CHILDREN'S HOSPITAL
OF ORANGE COUNTY

TOWER II

LOWER LEVEL MECHANICAL
PLAN AREA - M

M3.0M

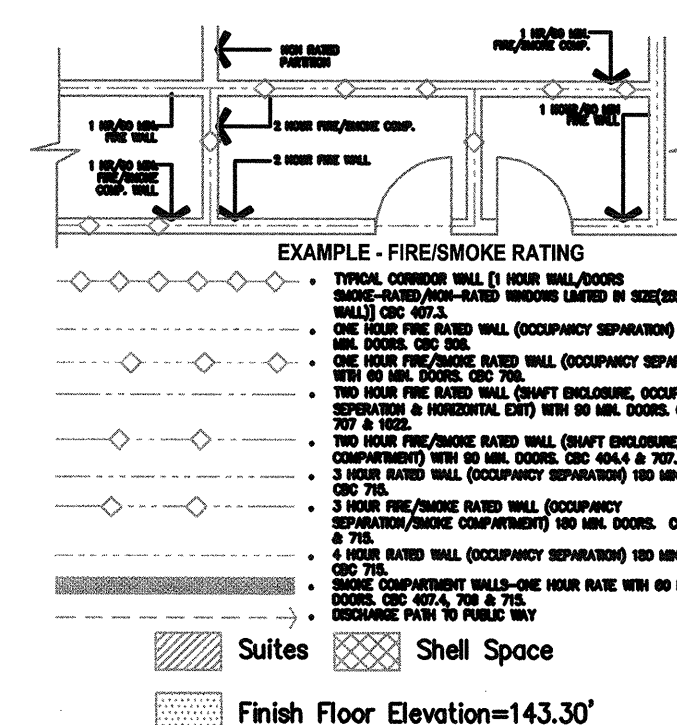
1	2.2.10	OSHPD Change Order #
28	05/19/2010	CHANGE ORDER #
166	01/24/2011	CHANGE ORDER #

RANGE ORDER# 139
 INSTRUCTION BULLETIN# _____
 DOWNSIDE APPROVAL# _____
 AIRCRAFT # _____
